STATE OF HAWAII DEPARTMENT OF TRANSPORTATION HIGHWAYS DIVISION	
INDEX TO DRAWINGS	
RAMP-IF	
STA: 78+17.13 TO STA: 85+37.69	
AIRPORT INTERCHANGE	
F.A.I. PROJECT No. I-HI-1 (174)16	
SCALE: N.T.S.	DATE: SEPT. 1982
SHEET No. I-1 OF 42 SHEETS

Contract Change Order No. 2 - Footing 30F Revision

STATE OF HAWAII DEPARTMENT OF TRANSPORTATION HIGHWAYS DIVISION	
REVISED FOOTING 30F DETAIL	
RAMP IF	
AIRPORT INTERCHANGE E.A.I. PROJ. NO. I-HI-1 (174) 16	
SCALE: AS SHOWN	DATE: JULY, 1983
SHEET NO. 8A OF SHEETS

SECTION B
Scale: 3/4" = 1'-0"

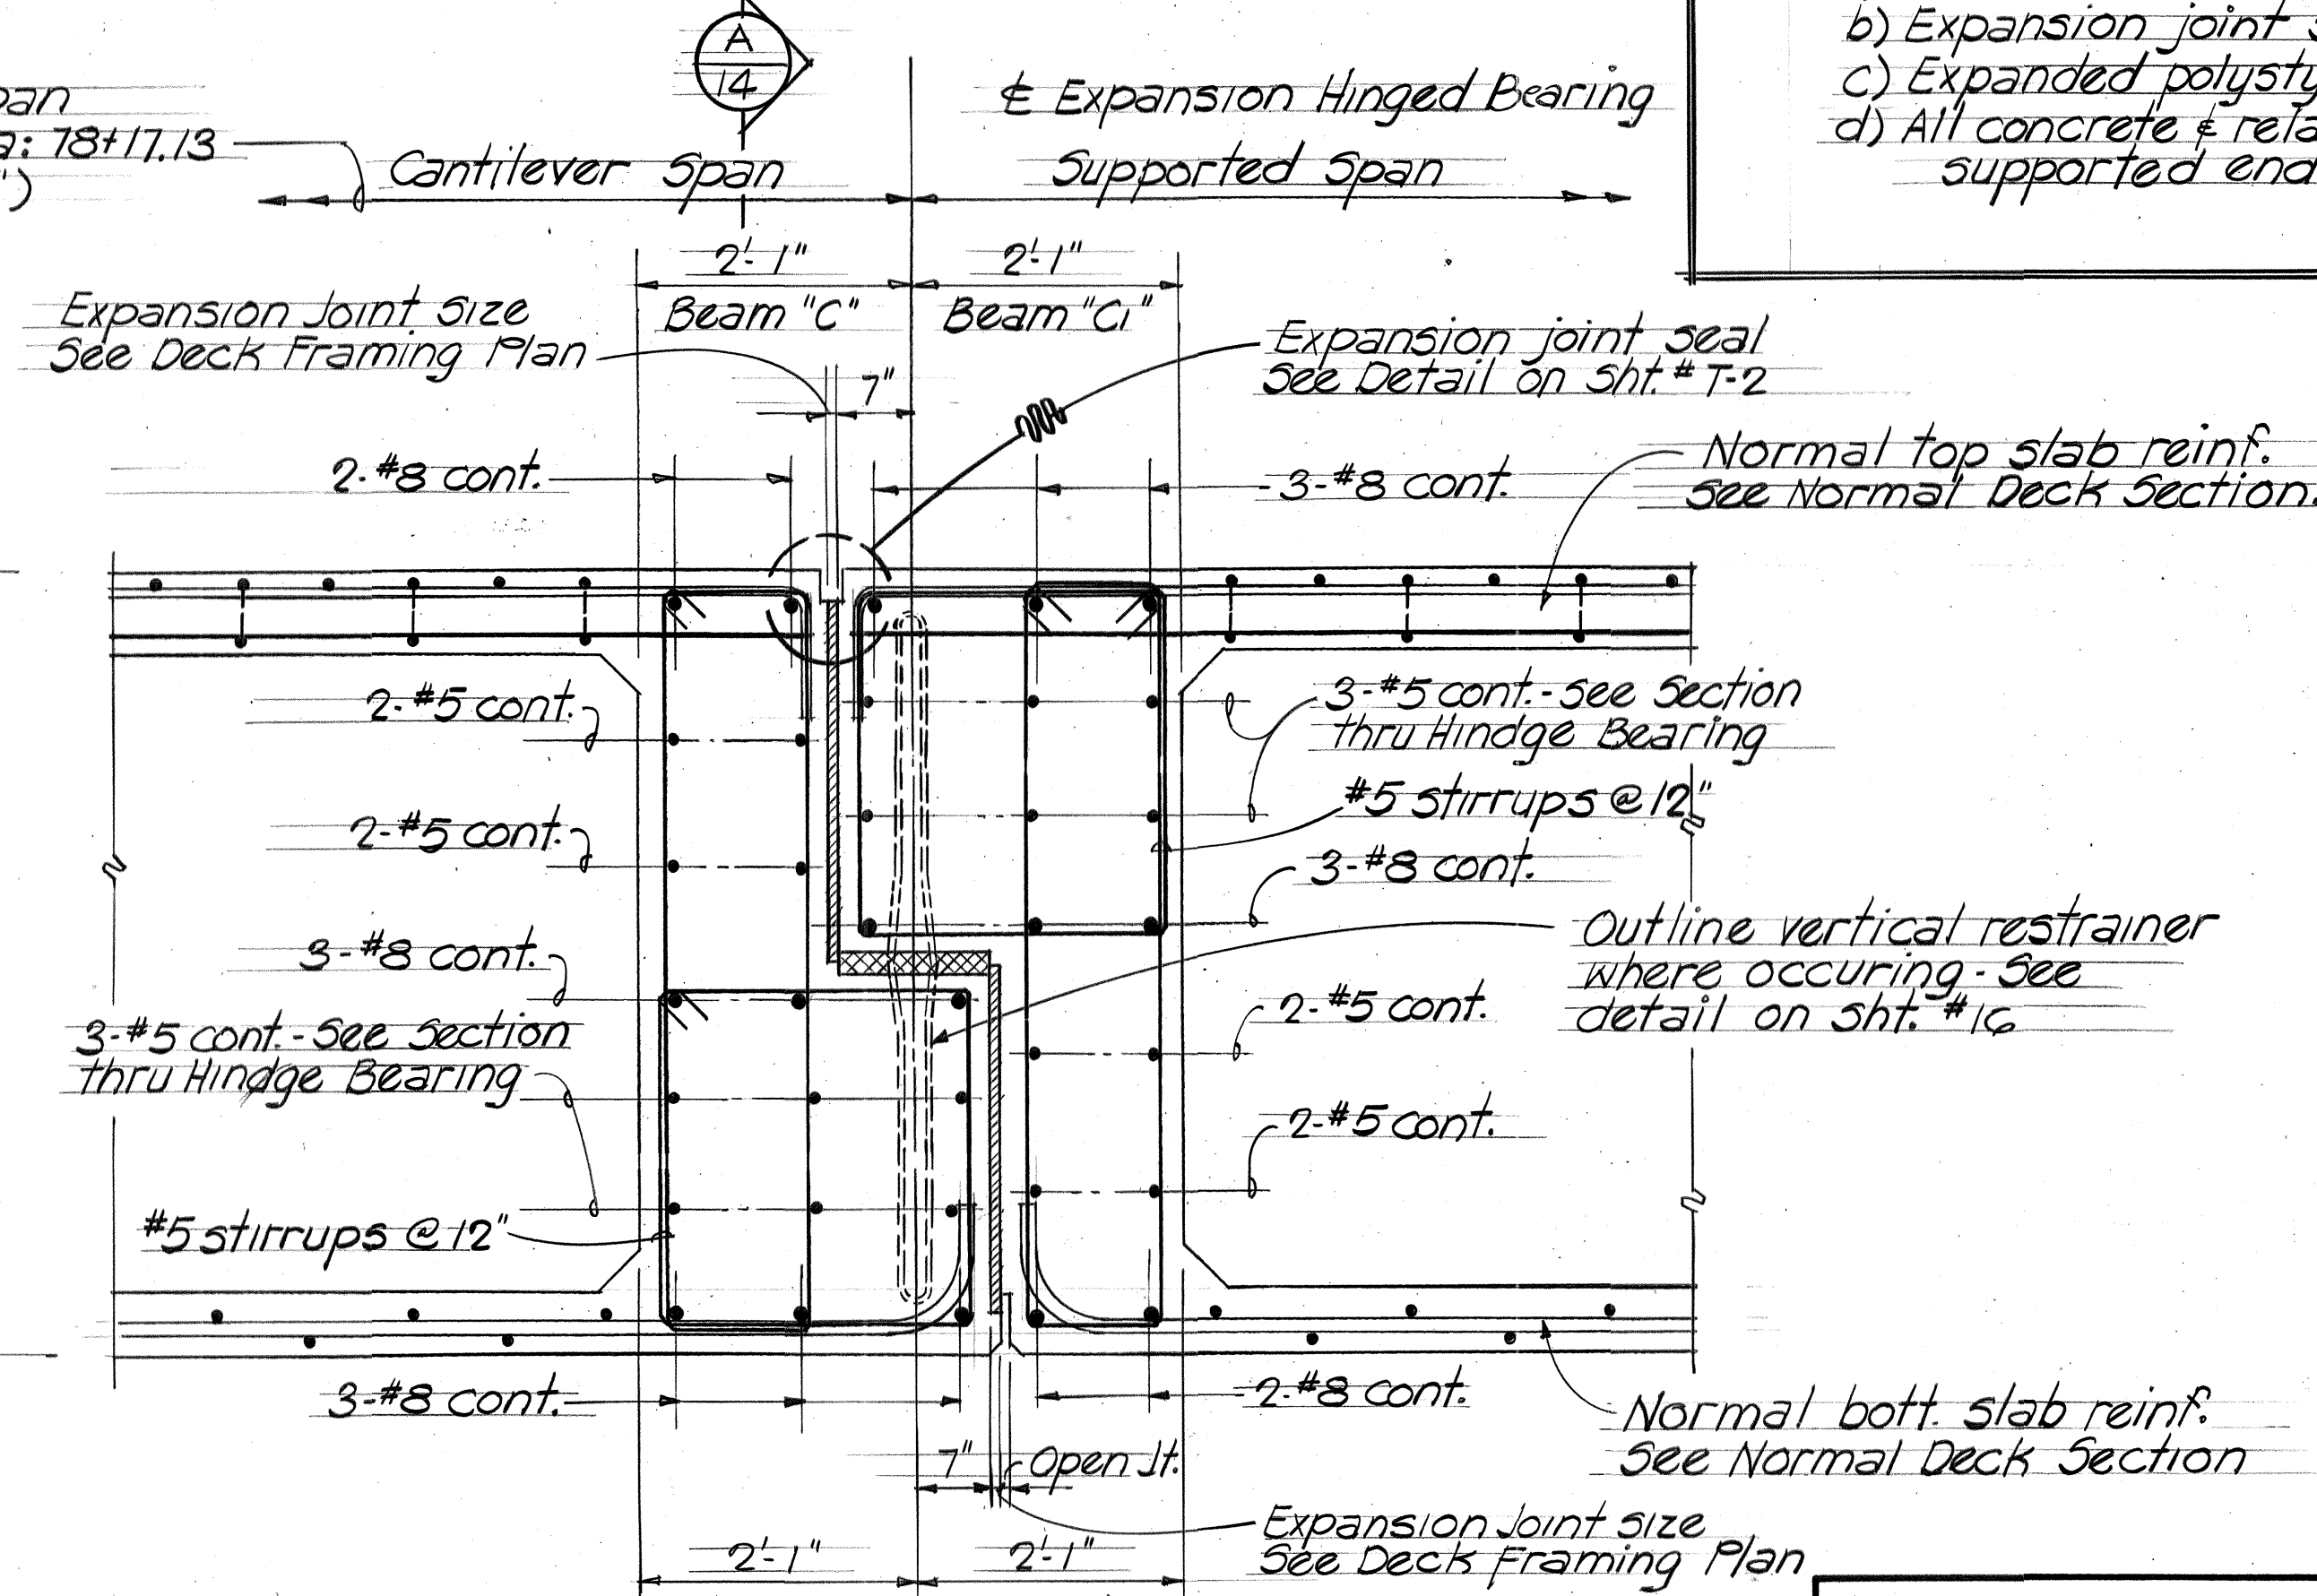
See C.C.O. No. 5 on Sht. 33.

STATE OF HAWAII DEPARTMENT OF TRANSPORTATION HIGHWAYS DIVISION	
HINGED BEARING DETAIL	
RAMP-IF	
STA: 78+17.13 TO STA: 85+37.69	
AIRPORT INTERCHANGE	
F.A.I. PROJECT NO. I-HI-1(174)16	
SCALE: AS NOTED	DATE: SEPT 1982
SHEET No. 14 OF 42 SHEETS

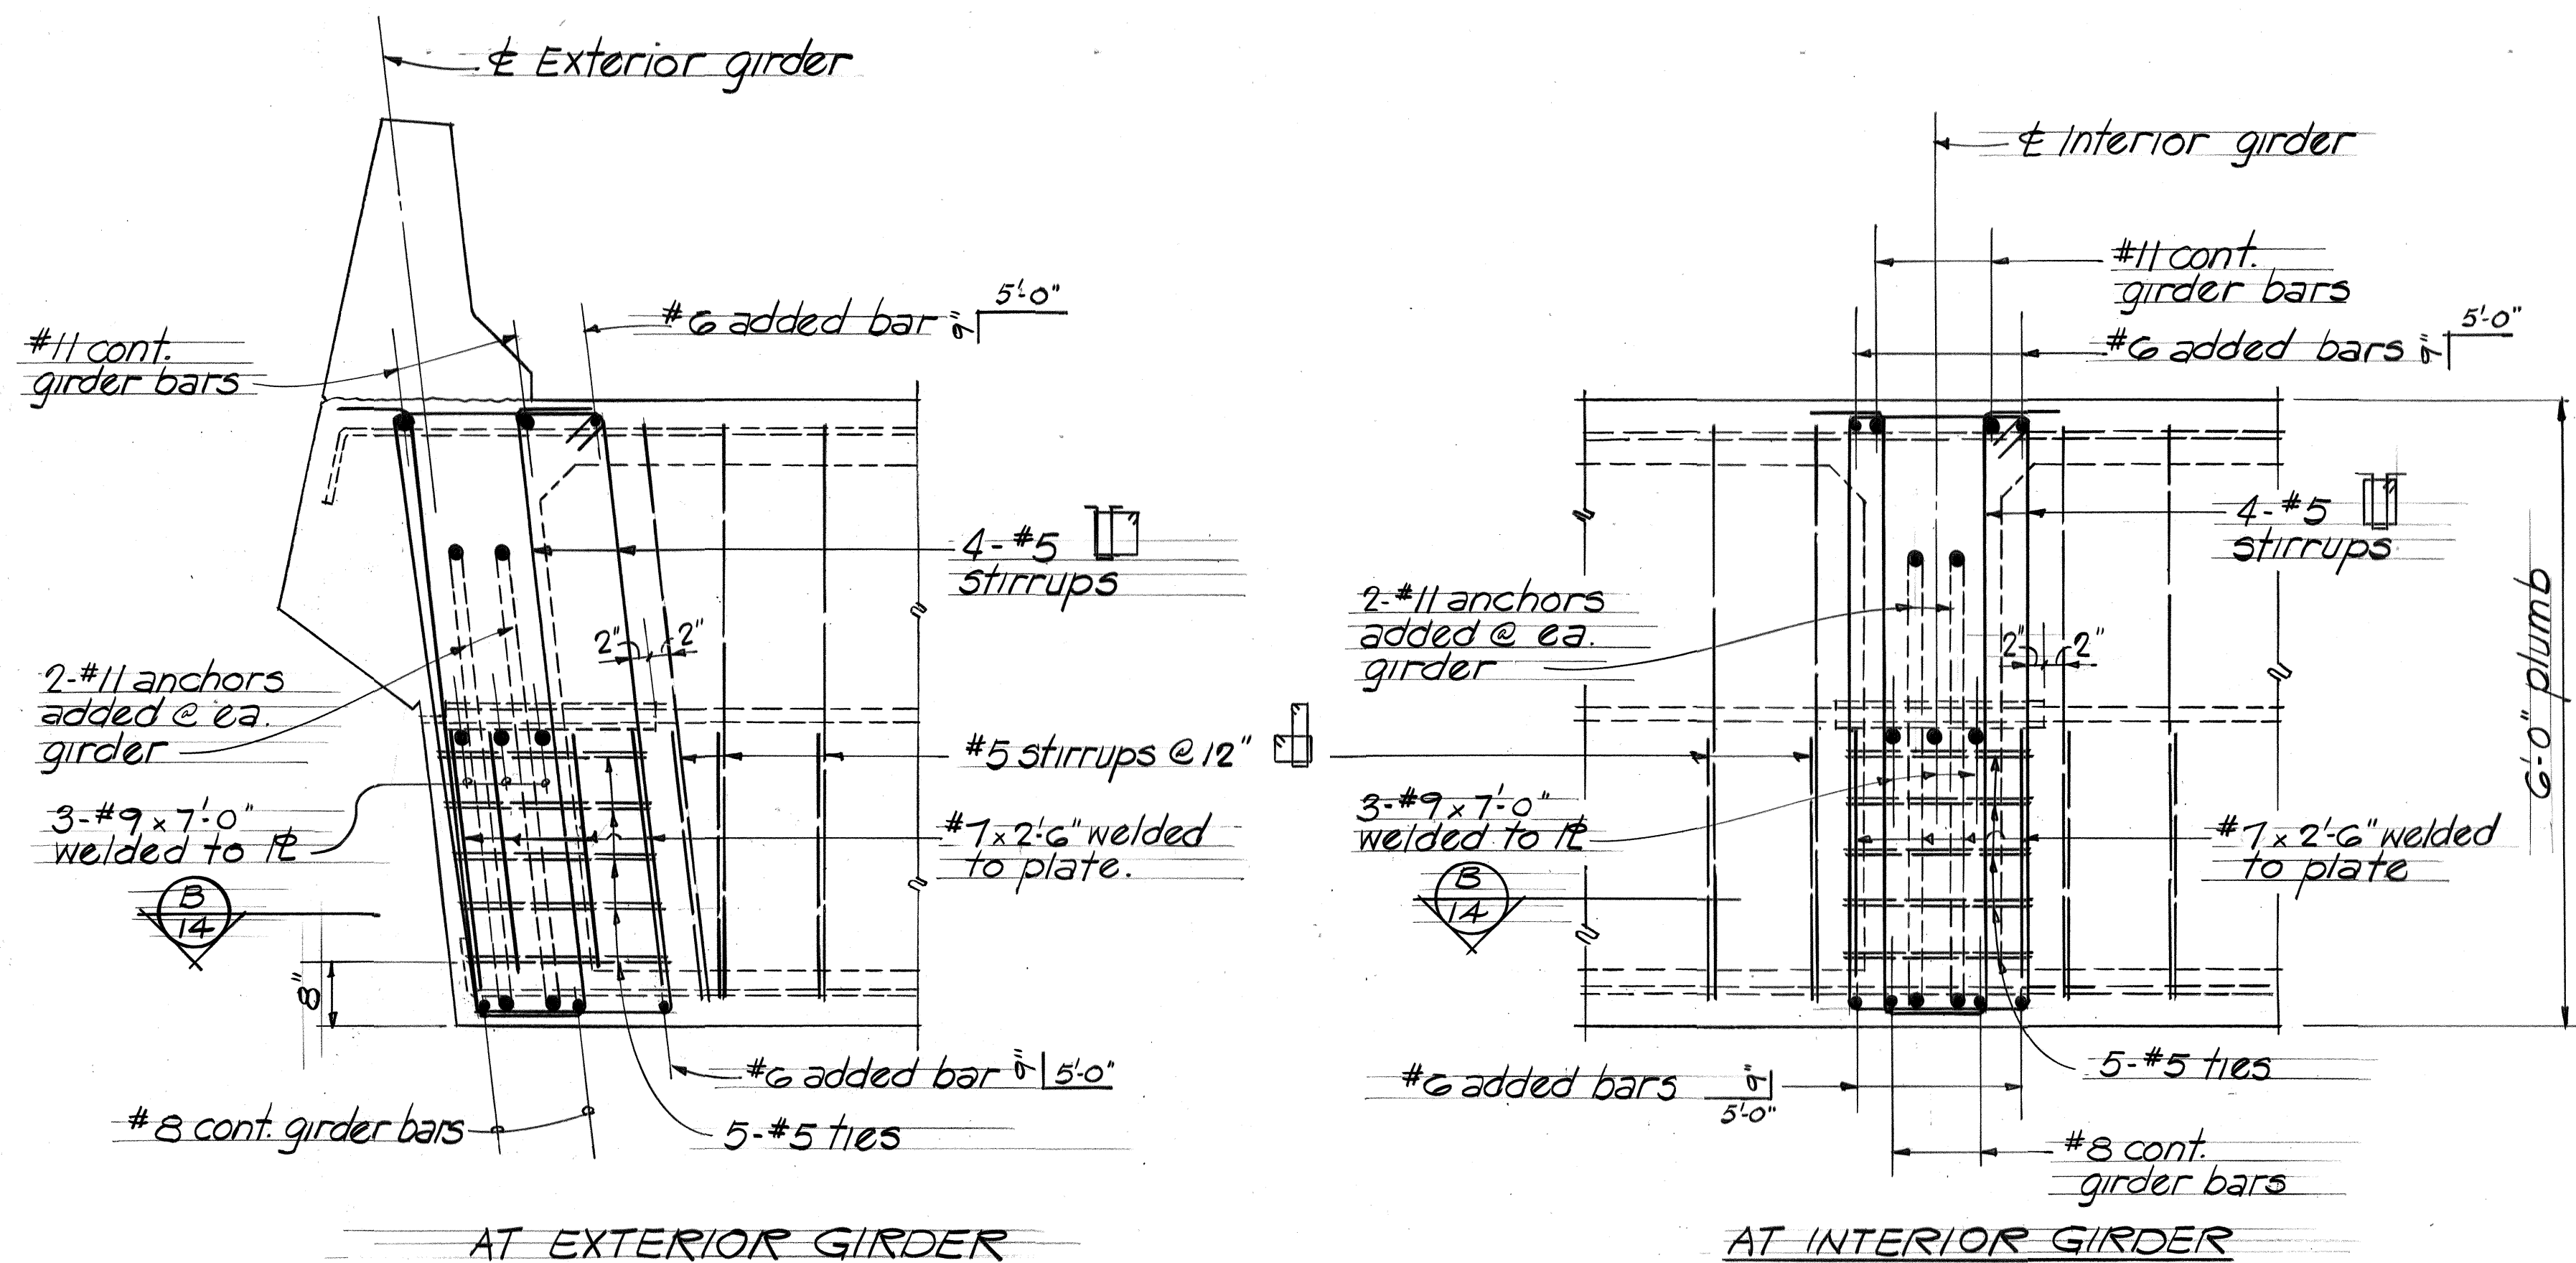
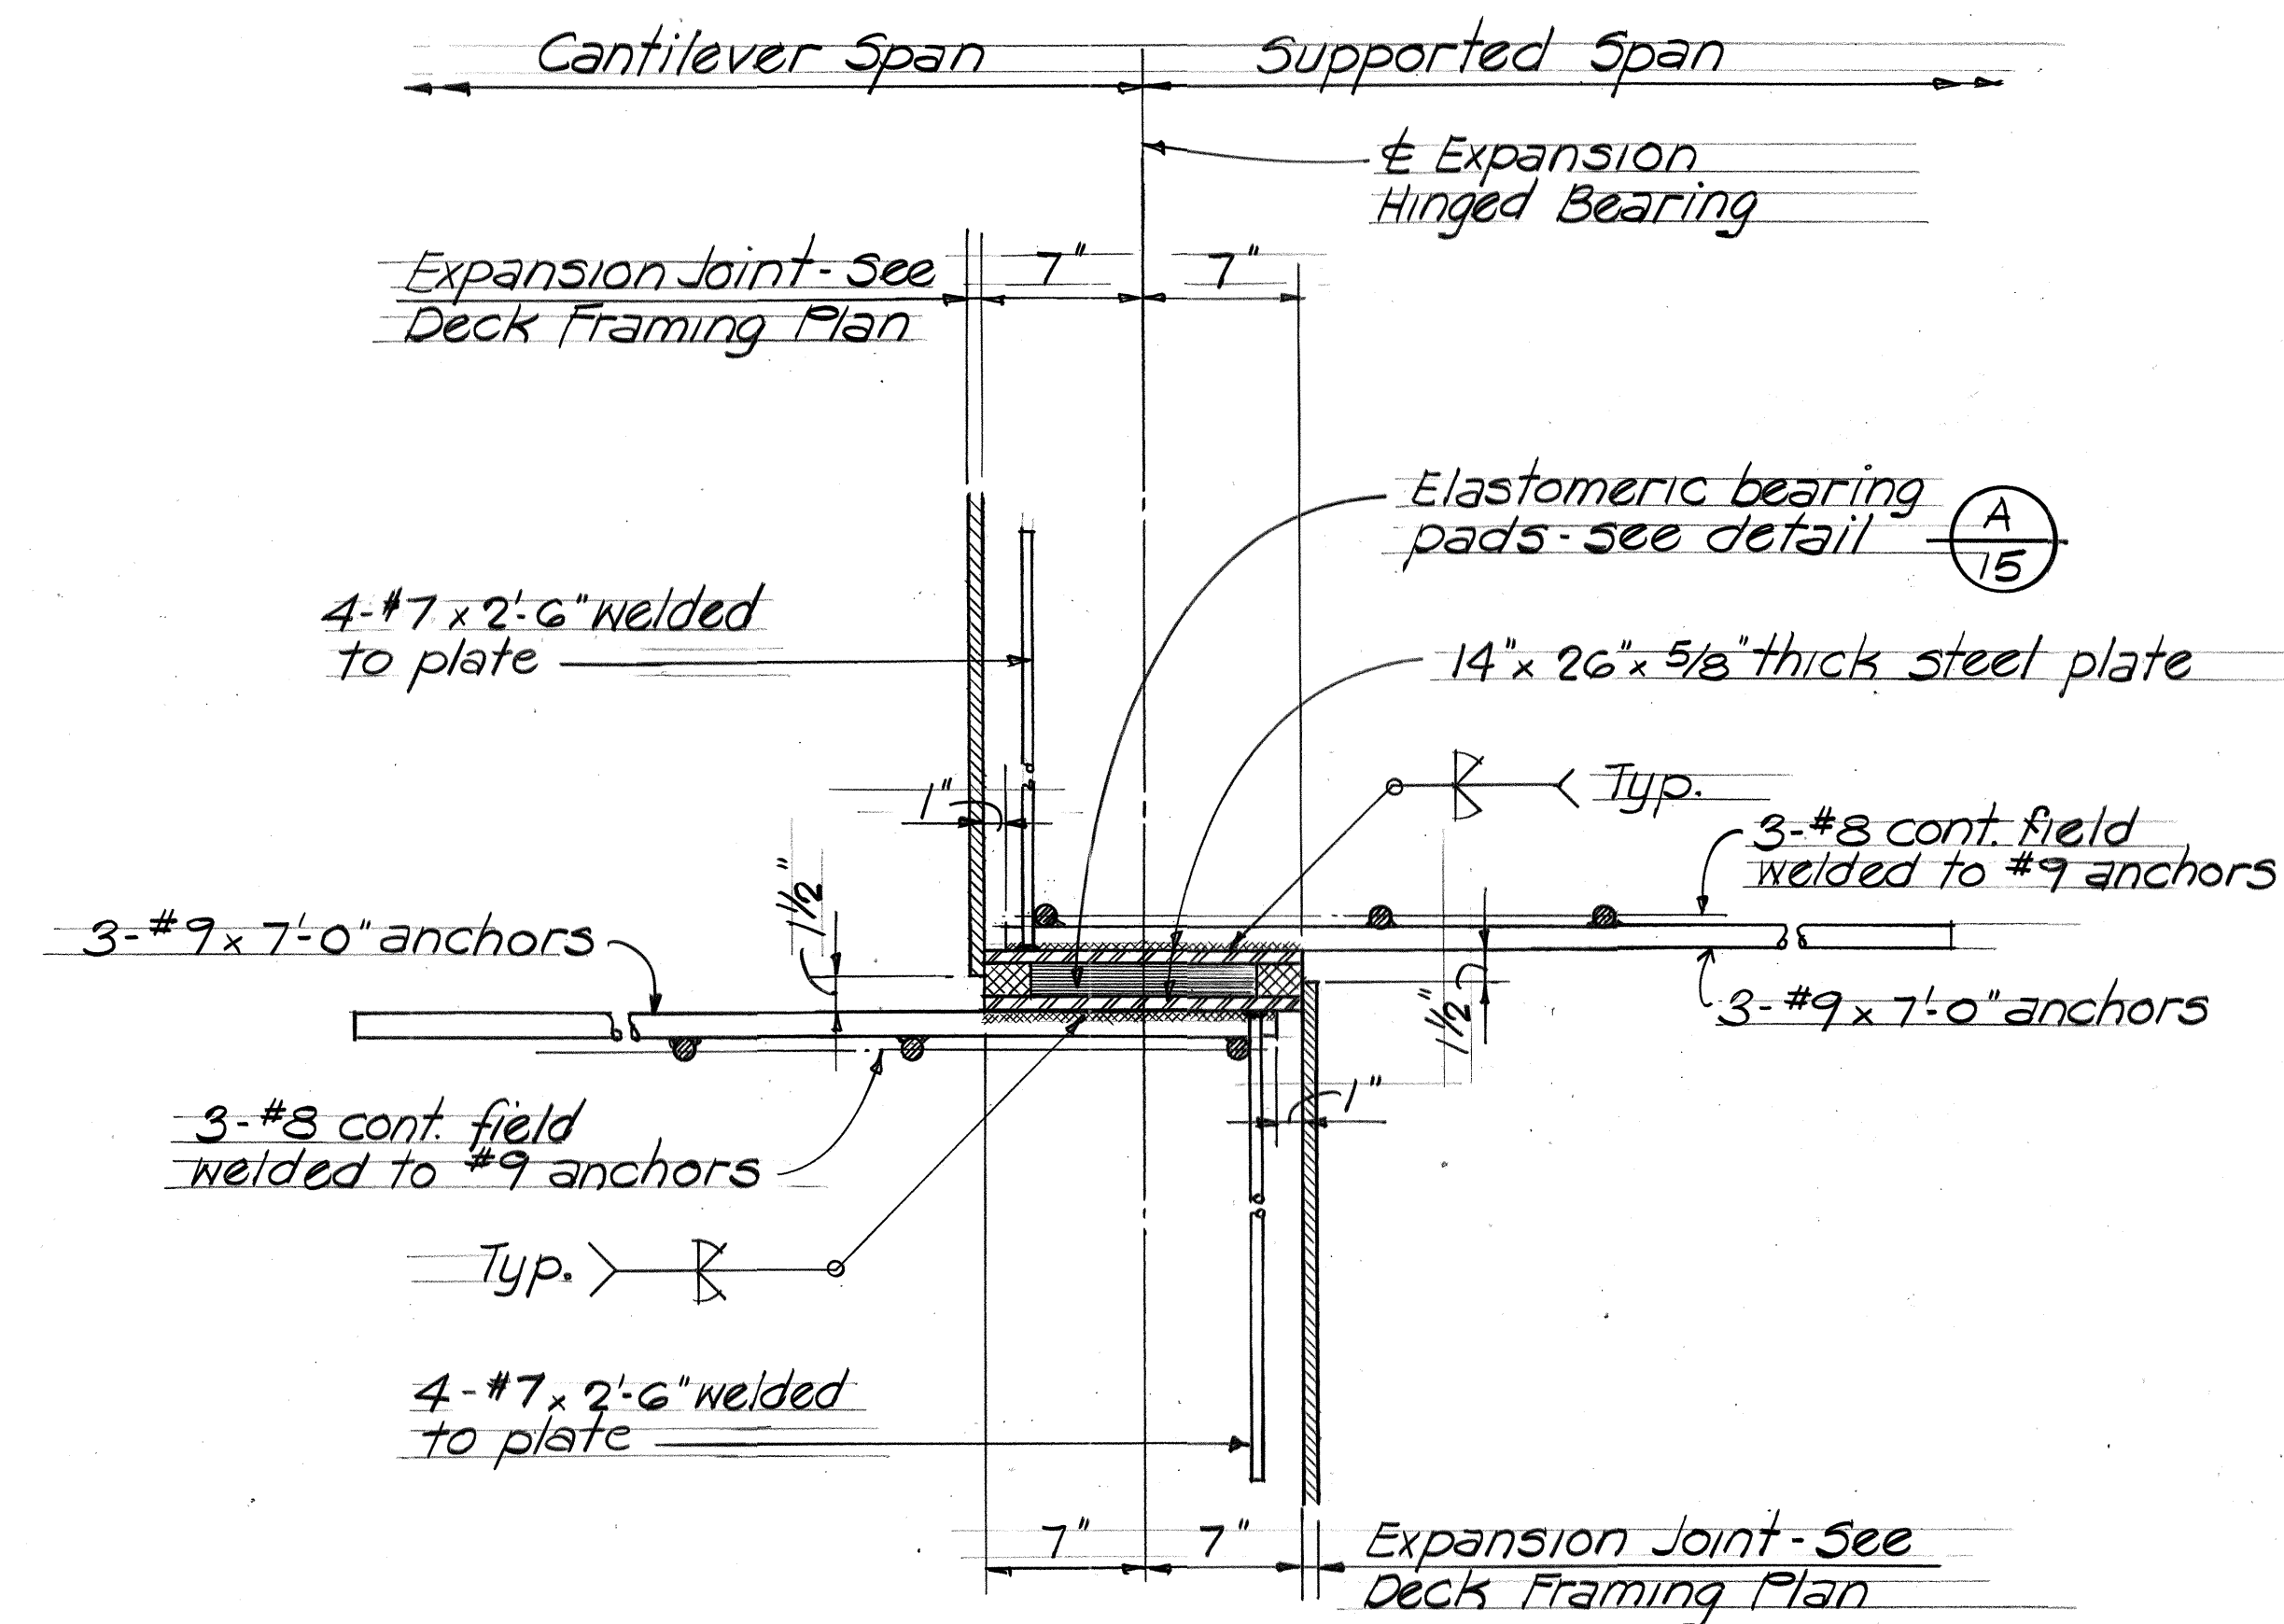
RECOMMENDED REVISIONS:

CONTRACT CHANGE ORDER NO. 5

- Revise #5 stirrups (fabricate longer) to compensate for deeper webs.
- Place #11 using original cover as shown in contract plans at bottom slab and vertical face. Let top slab take up the balance.
